ADDENDUM NO. 2

Re: **GS# 506-037**
Central Warehouse Renovations
Mississippi Forestry Commission
Pearl, Mississippi

ADDENDUM NO. 2

PROJECT: GS# 506-037
Central Warehouse Tenant Improvements
Mississippi Forestry Commission

FLOOR PLAN - PLUMBING - DEMOLITION
SCALE: 1/8" = 1'-0"

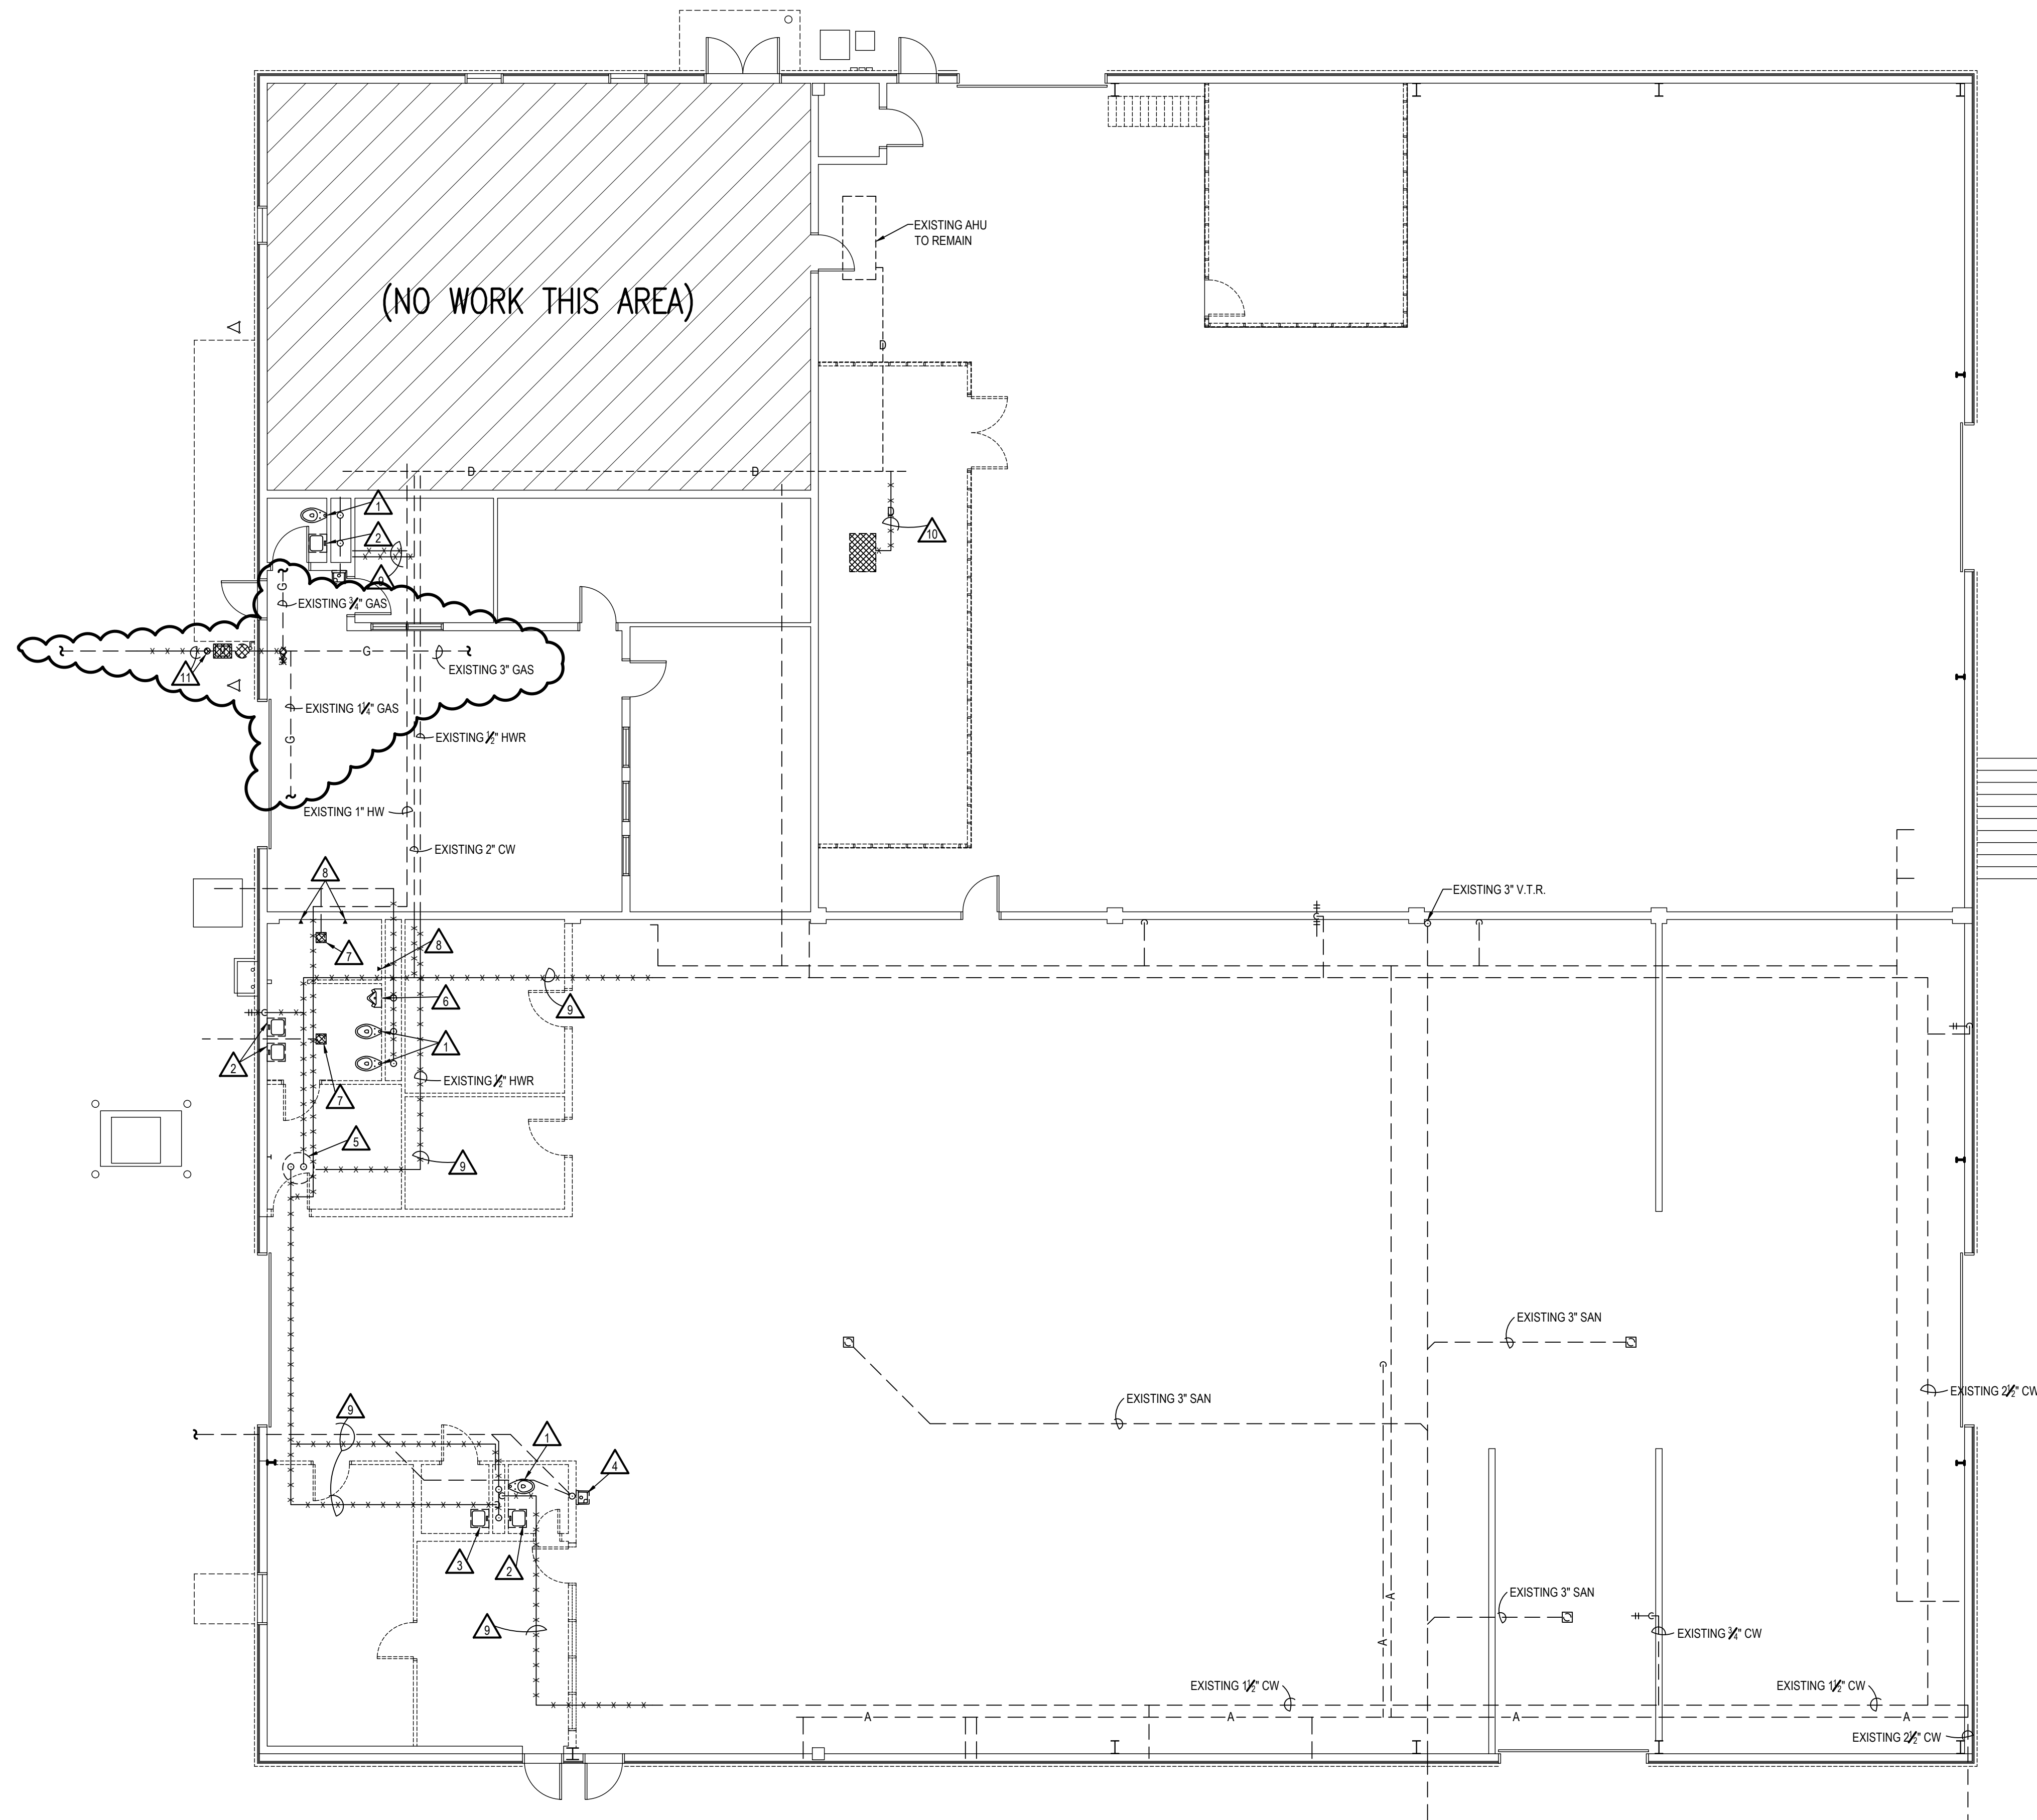
- Item No. 1: Drawings, Sheets P1 and P2: Relocate existing gas meter, regulator, and building service entry and reconnect to existing building gas service as shown on attached Drawings P1R1 and P2R1.

- 10) REMOVE EXISTING CONDENSATE PIPING AND RELATED HANGERS BACK TO MAIN. CAP BRANCH LINE AT MAIN.
 - 11) EXISTING GAS METER, REGULATOR, MEDIUM PRESSURE GAS PIPING TO BE REMOVED AND RELOCATED BY SERVING UTILITY. REMOVE EXISTING GAS BUILDING ENTRY PIPING AS SHOWN.

NO	REVISION	DATE
1	ADDENDUM #2	7-8-19
DATE: MAY 21, 2019		
PROJECT NO. JAN18068		
Sheet Number FP1R1

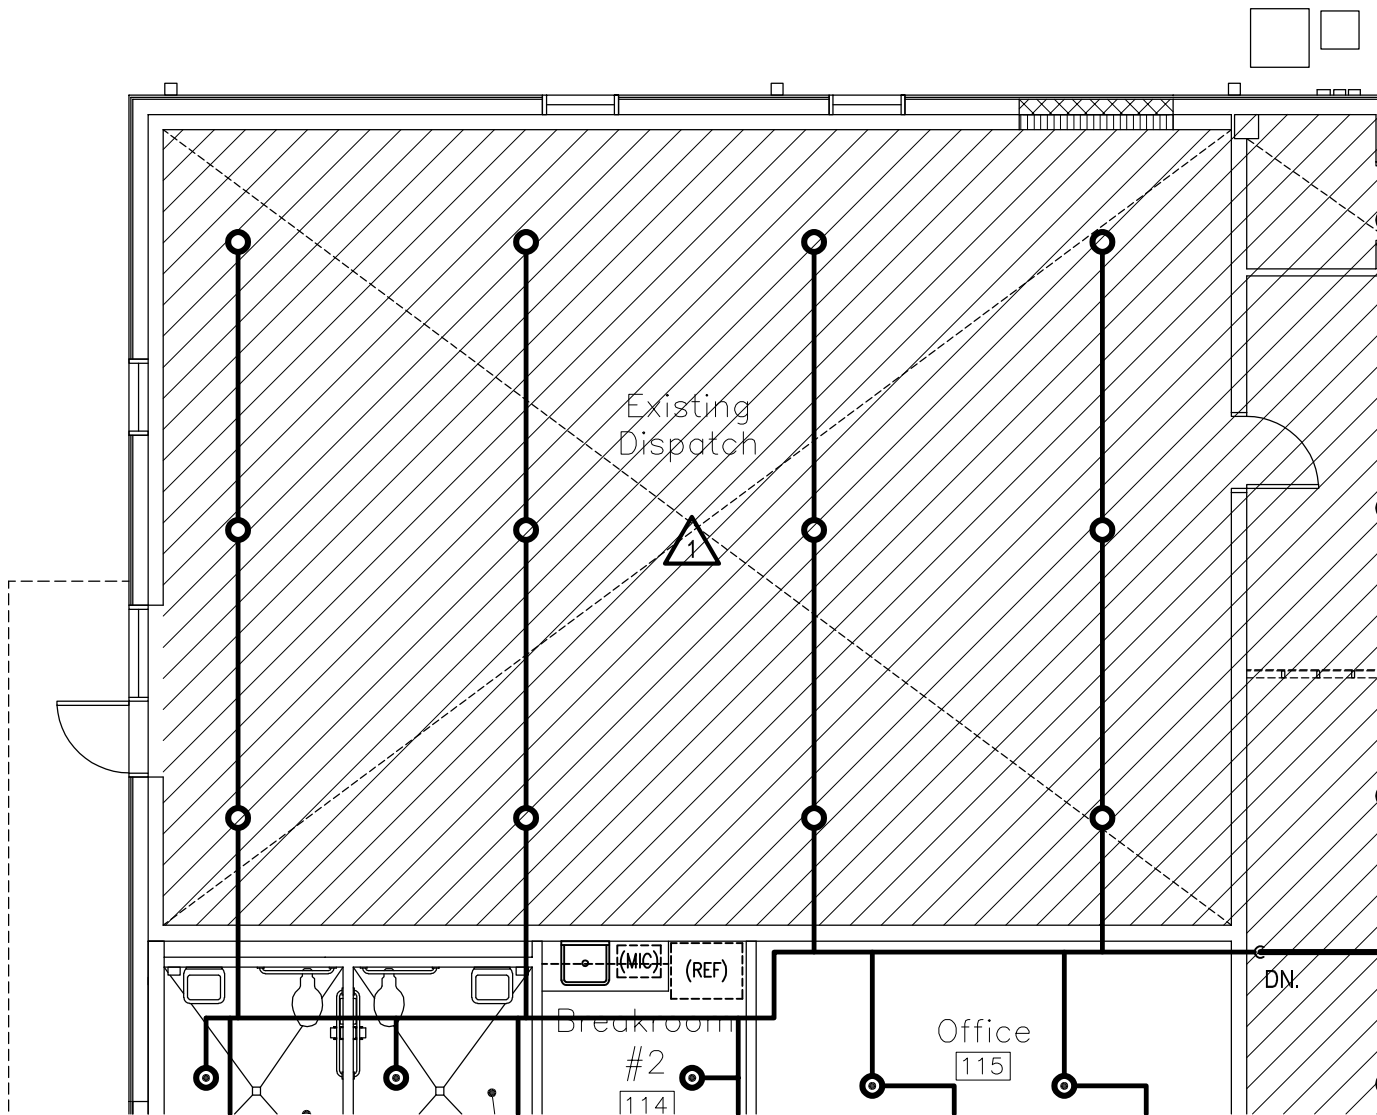
- Item No. 2: Drawings, Sheet FP1: Revise note about coordinating fire protection installation in dispatch area as shown on attached Drawings FP1R1.
- Item No. 3: Drawings, Sheet ED1: See attached Drawing ED1R1 for added Floor Plan General Notes and edited notes located on the floor plan.

1 FIRE SUPPRESSION WORK IN EXISTING DISPATCH ROOM IS TO BE COORDINATED WITH OWNER AND PERFORMED IN SEVEN CALENDAR DAYS TIME. NEW FIRE PROTECTION SYSTEM SHALL BE INSTALLED ABOVE EXISTING LAY-IN CEILING. COORDINATE PIPE ROUTING AND HEAD LOCATIONS WITH EXISTING DUCT, PIPING, AND CEILING MOUNTED LIGHTS. (SEE GENERAL NOTE ON ARCHITECTURAL SHEET "1".)

FLOOR PLAN - LIGHTING
SCALE: 1/8" = 1'-0"

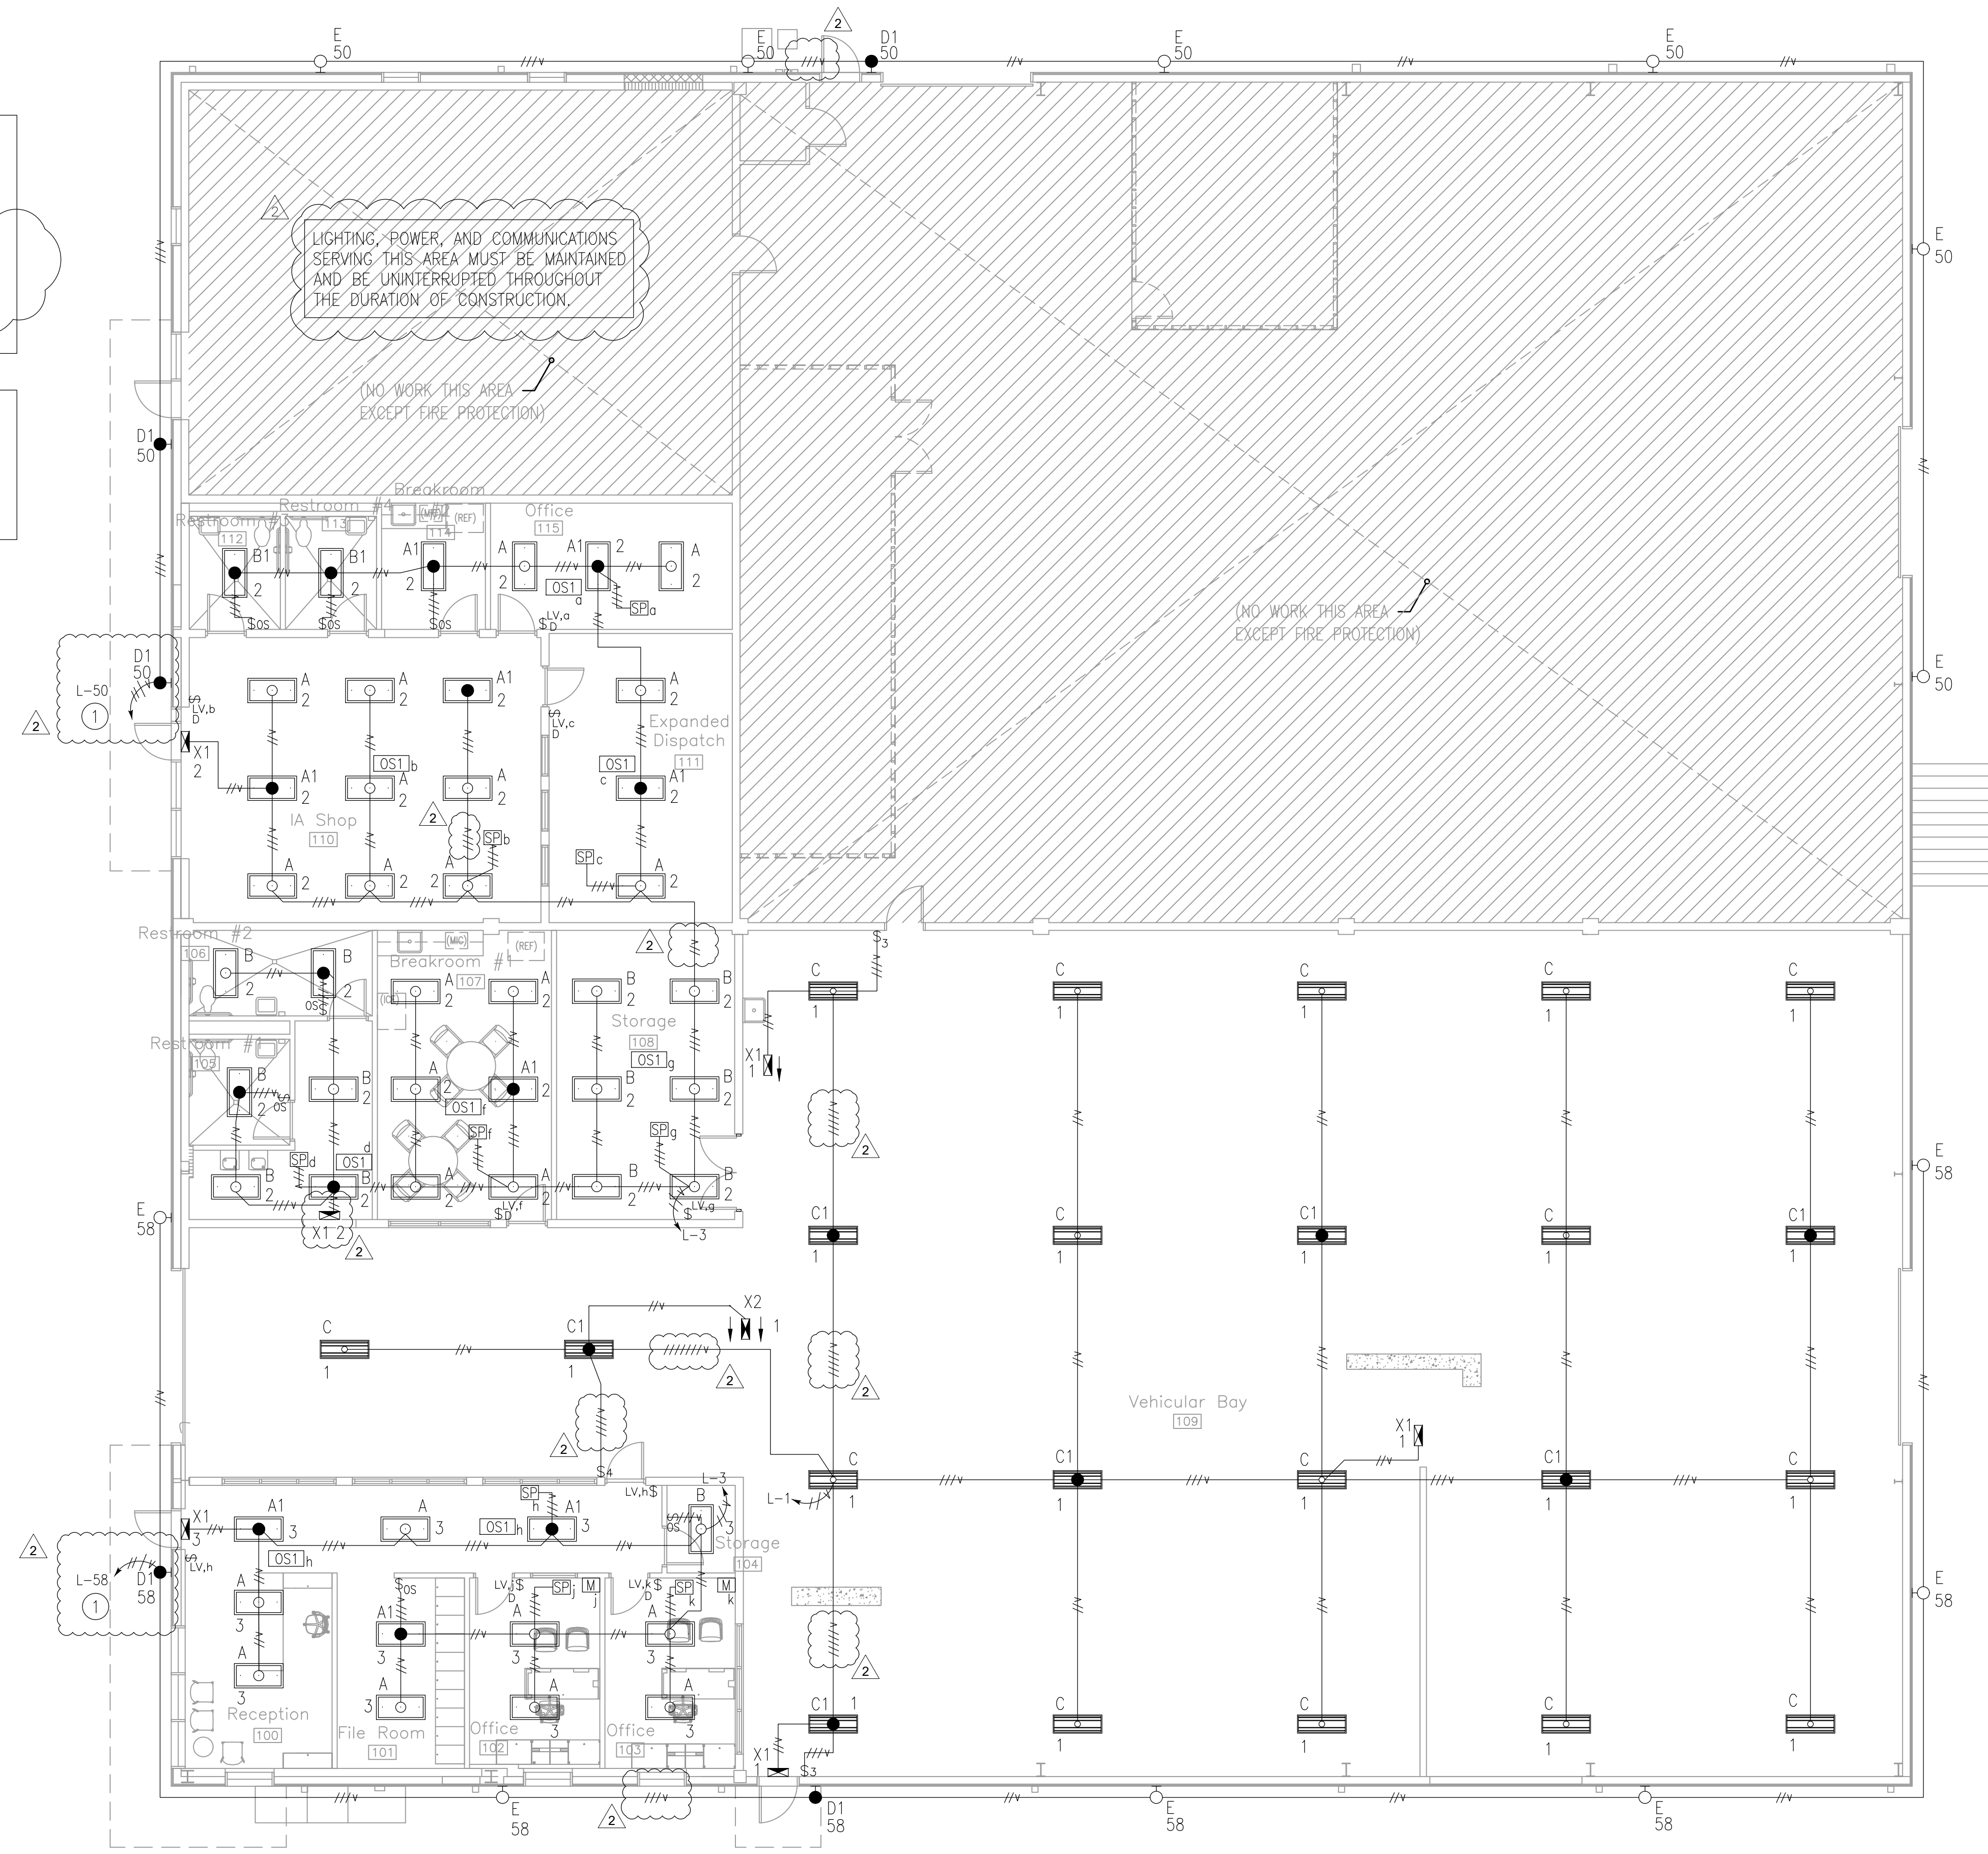
- Item No. 4: Drawing Sheet E4: See attached Drawing E4R1 for added General Notes 'B' and 'C', added note located on floor plan, and for adjusted lighting circuitry.

- A. SEE SHEET E7 FOR CEILING MOUNTED OCCUPANCY SENSOR DETAIL 2/E7.
- B. SEE ARCHITECTURAL ELEVATIONS FOR LOCATIONS OF WALLPACKS.
- C. CONTRACTOR SHALL REINSTALL ALL EXISTING ELECTRICAL CONDUITS AND ELECTRICAL PENETRATIONS THROUGH THE EXTERIOR WALL. CONTRACTOR SHALL REINSTALL CONDUIT AND EXISTING CIRCUITRY AND RECONNECT EQUIPMENT AND DEVICES. ANY DAMAGED CONDUIT OR CIRCUITRY SHALL BE REPLACED. ALL WALL PENETRATIONS SHALL BE SEALED.

- ① ROUTE THROUGH ASTRONOMIC CLOCK WITH PHOTOCELL. PROVIDE INTERMATIC ET1100 SERIES, OR EQUAL. MOUNT ADJACENT TO PANEL SERVING EXTERIOR LIGHTING.
